FERGUSON-DEERE, INC.
CONSULTING ENGINEERS
9817 KINGSLEY ROAD
DALLAS, TEXAS
75238
PHONE 348-2821
DATE

DRAINAGE PLANS
GREENHAVEN VILLAGE

SCALE
H-1"=40'
V-1"=4'
SHEET NO.
CE/3

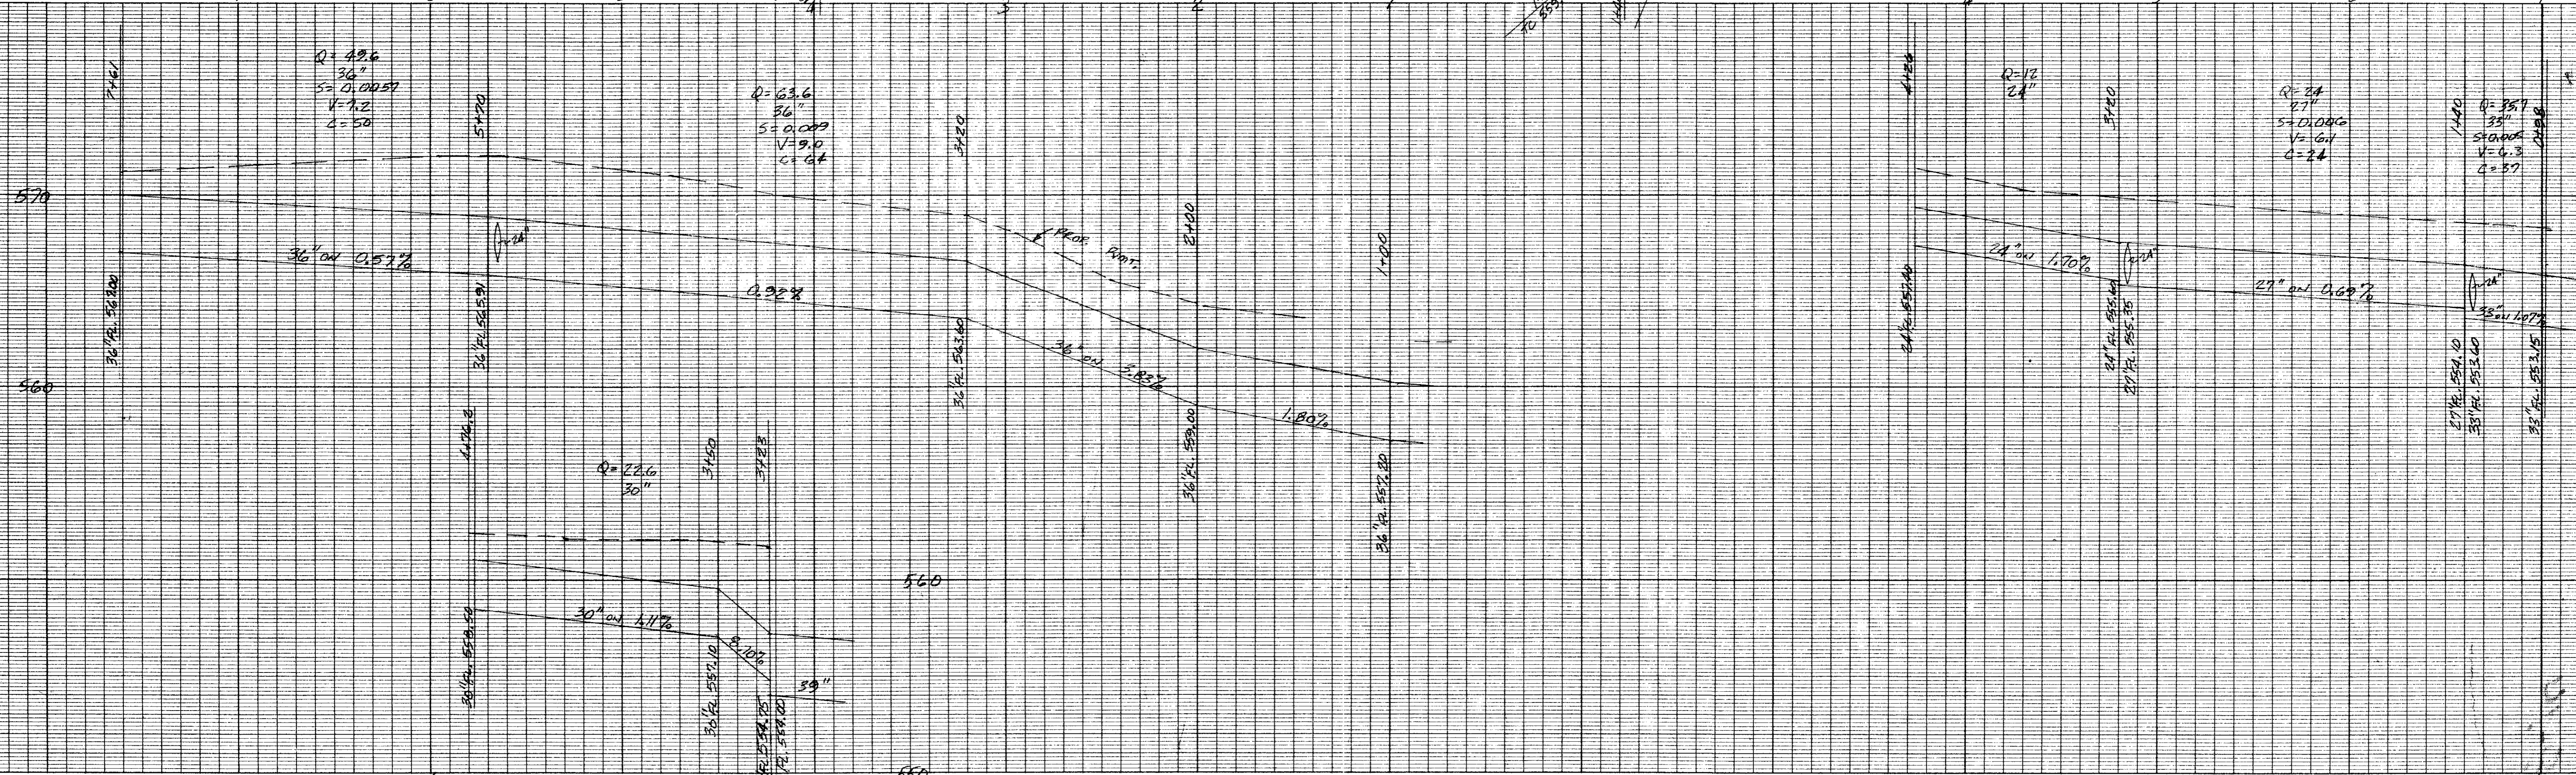
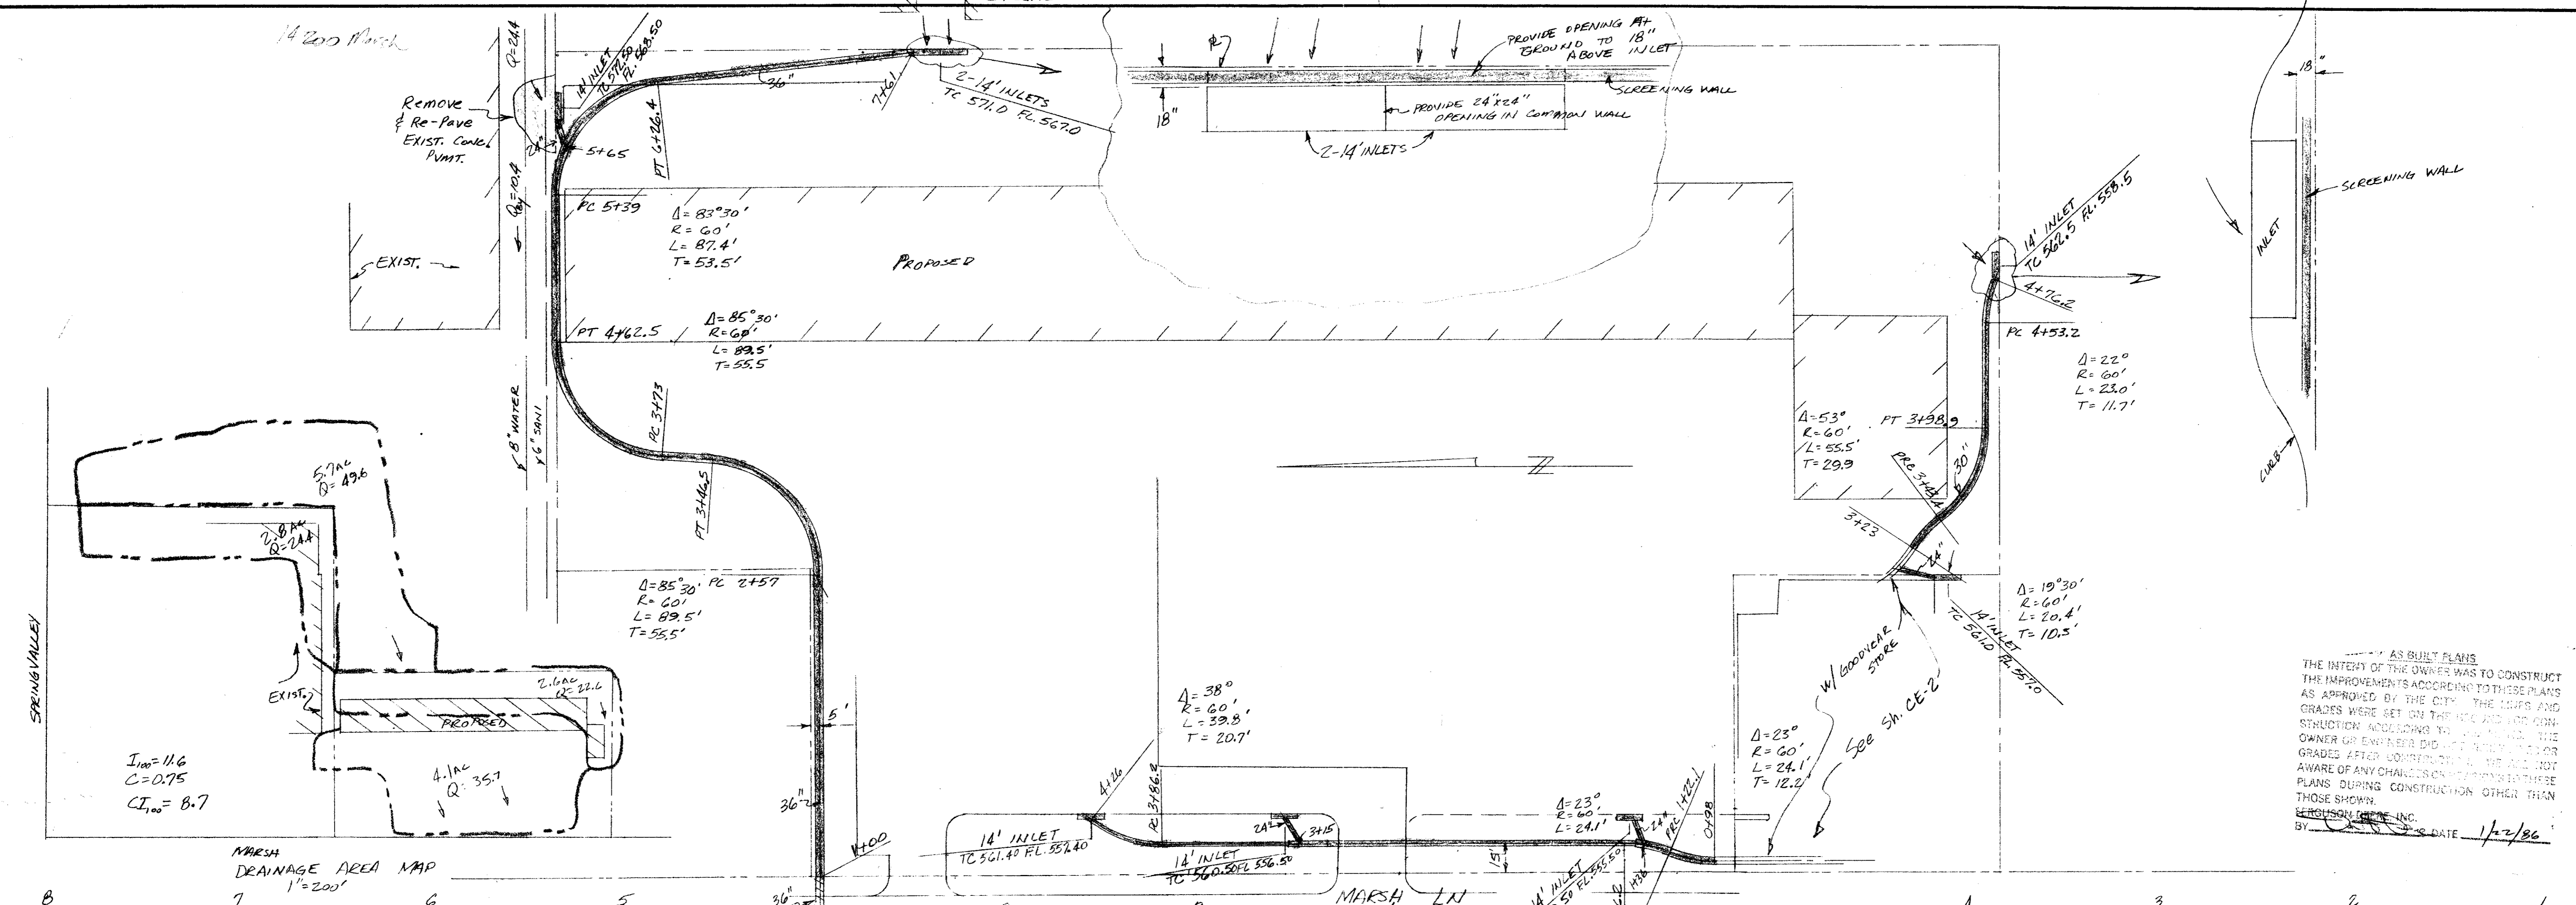
Remove & Re-Pave EXIST. CONCR. PAVT.

PROVIDE OPENING AT 18" GROUND TO ABOVE INLET

PROVIDE 24"x24" OPENING IN COMMON WALL

DAD	4/18/85	REV. INLET @ 146 on Marsh
DAD	4/18/85	MOVE INLETS @ SCREENING WALL
DAD	3/22/85	PARKING REL. - LANDSCAPING
REVISED BY	DATE	COMMENT
